# NATIONAL TRANSPORTATION SAFETY BOARD

MATERIALS LABORATORY FACTUAL REPORT—ERRATA SHEET Report No. 10-119

Place : San Bruno, California  
Date : September 9, 2010  
Vehicle : Pacific Gas & Electric Natural Gas Transmission Pipeline  
NTSB No. : DCA10MP008  
Investigator : Ravindra Chhatre, RPH-20

Page 36

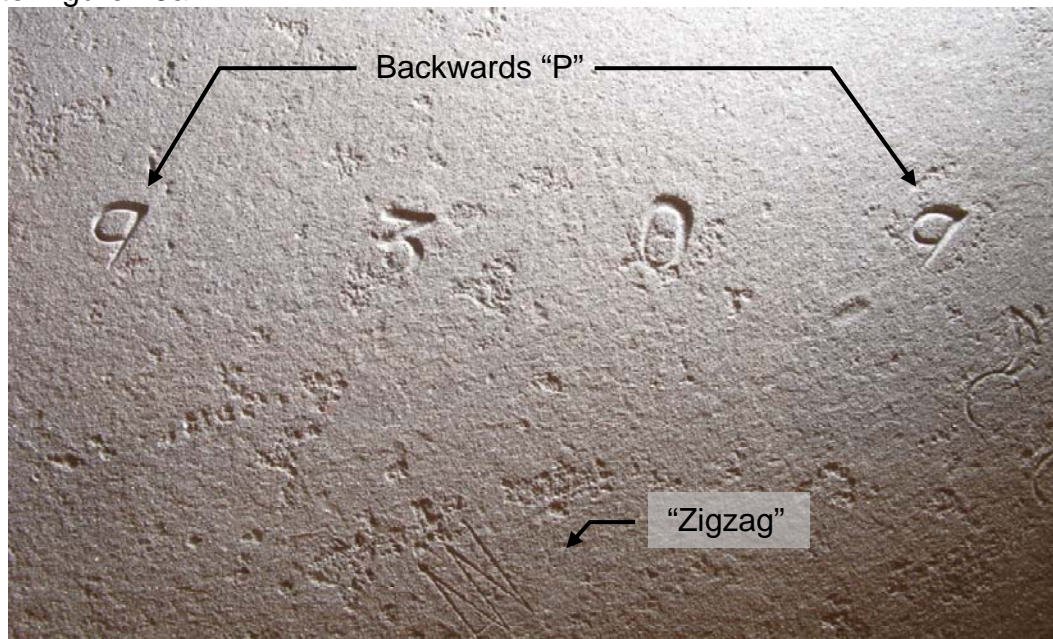
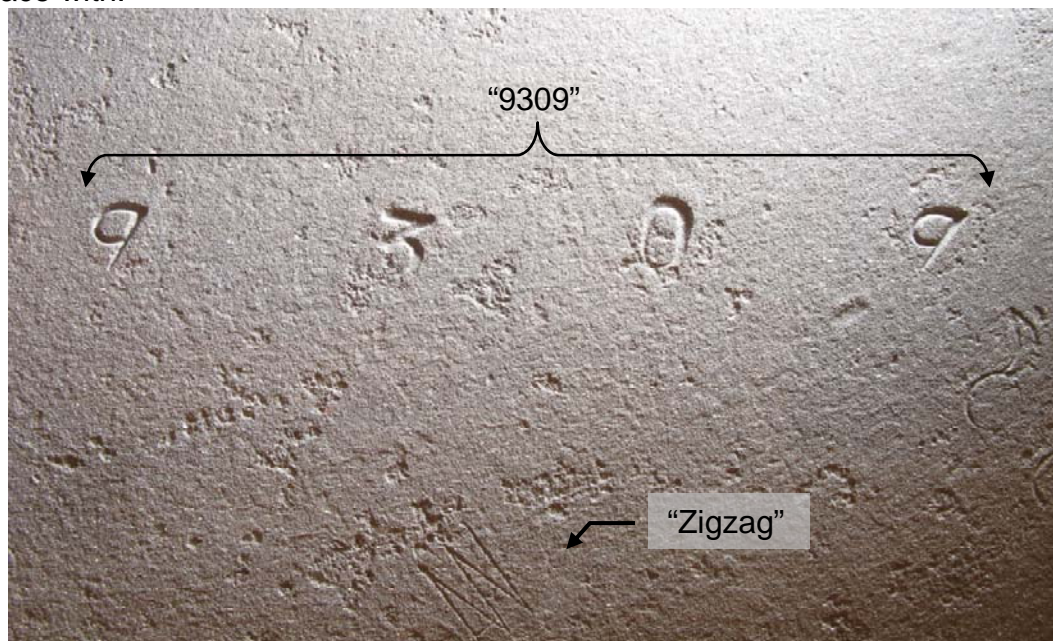
Delete Figure 19a:

Replace with:

Page 59

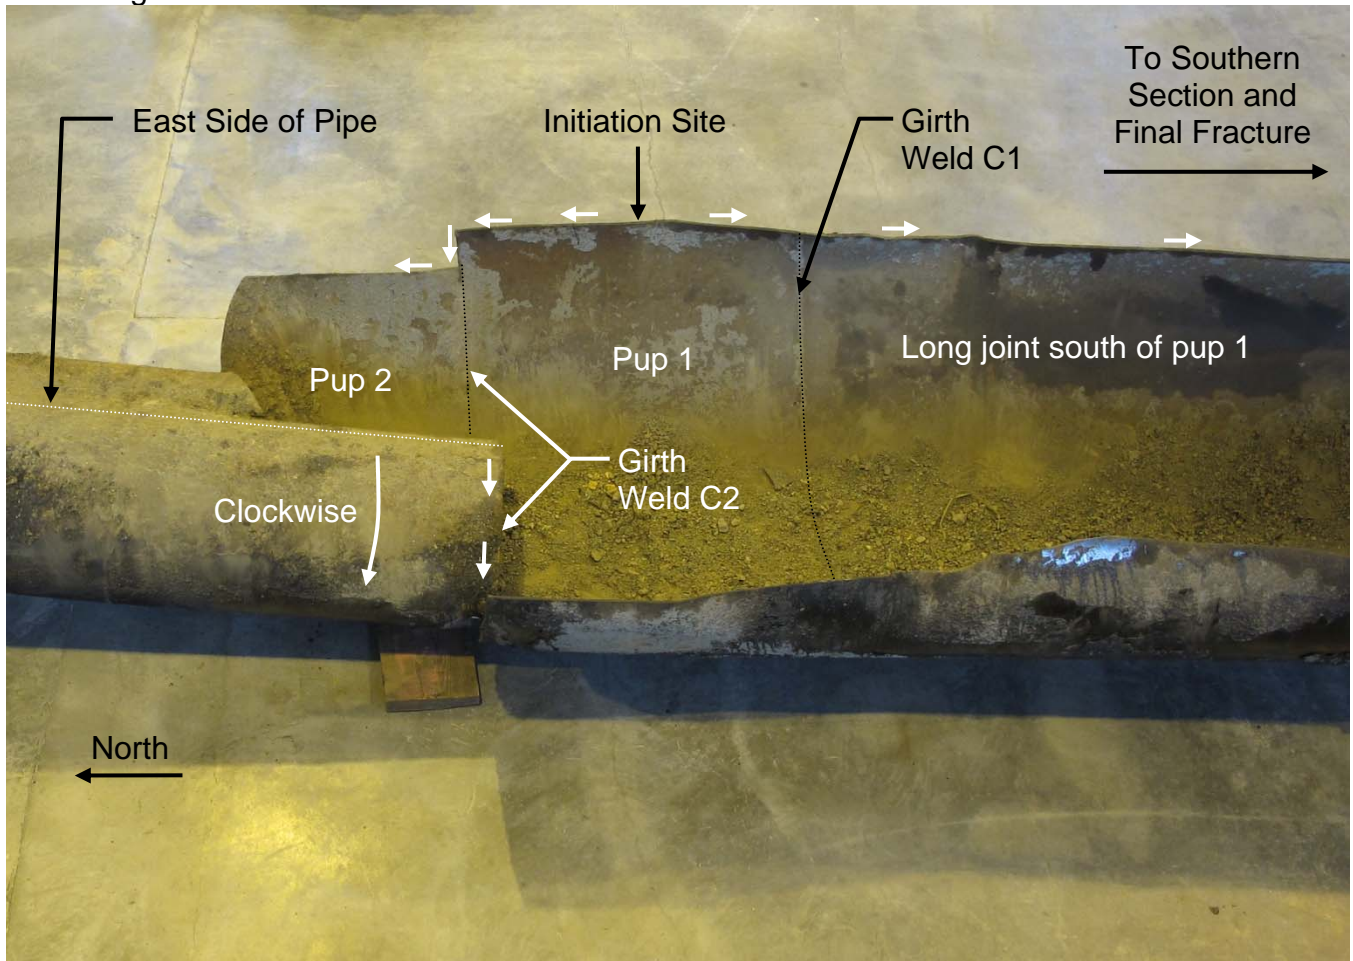
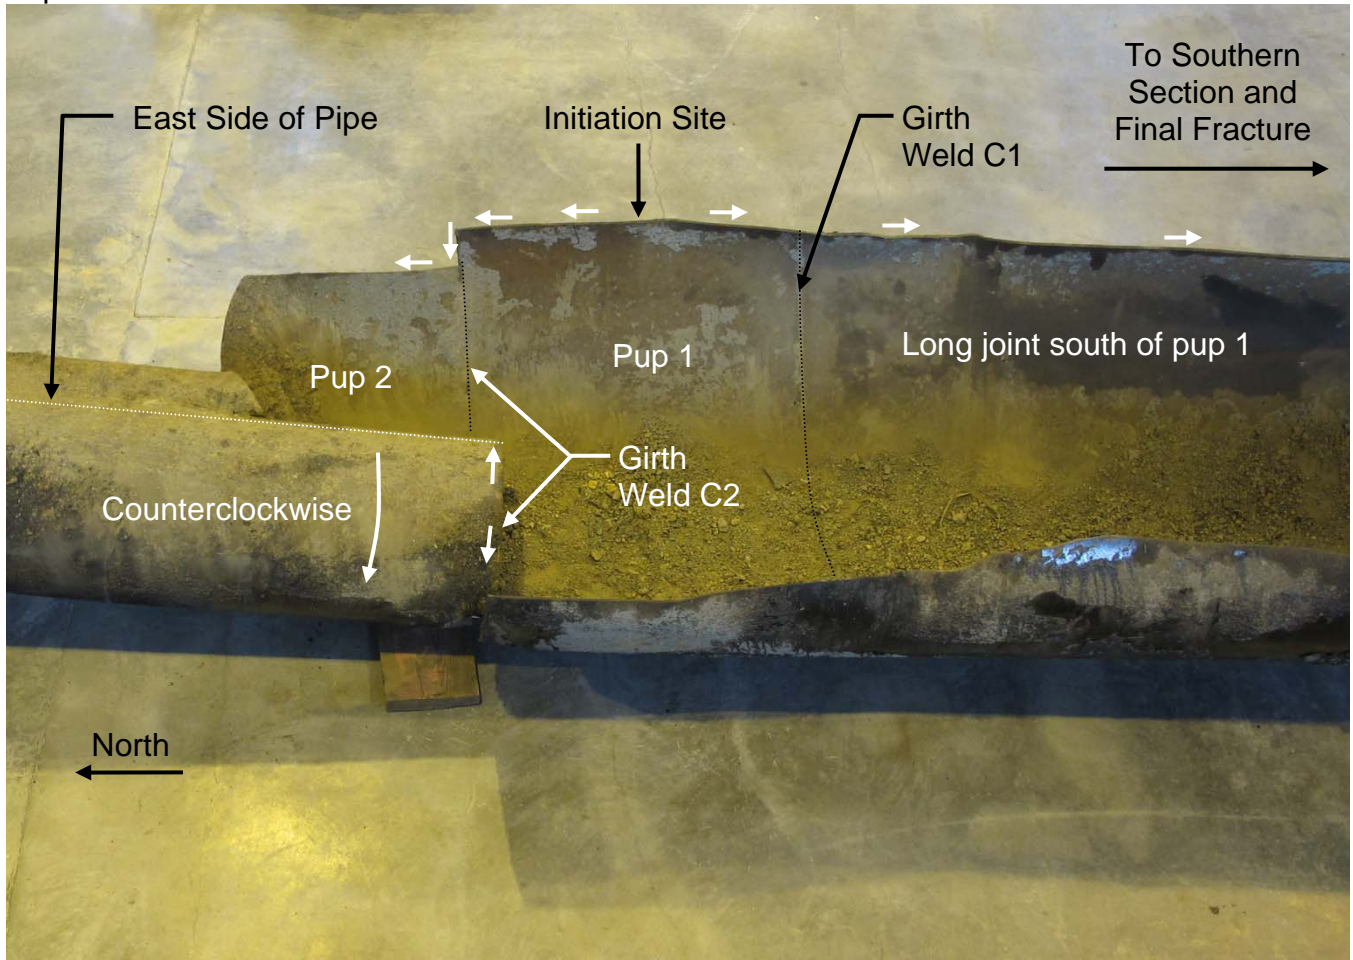
Delete Figure 41:

Replace with:
